4/8/25

# People for the Plains Submission to Maules Creek Continuation Project

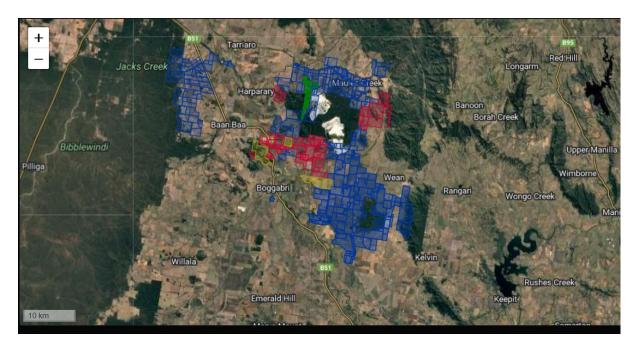
The satellite image below shows that Whitehaven now controls an estimated >75,000 hectares of land in the Maules Creek-Boggabri area. This includes mining leases, farms used for water, biodiversity offset zones and extensive buffer properties. The scale of land control is industrial and unprecedented. What began as a small project reliant on Crown forest now sprawls across private farmland and entire catchments, all with minimal scrutiny or transparency.
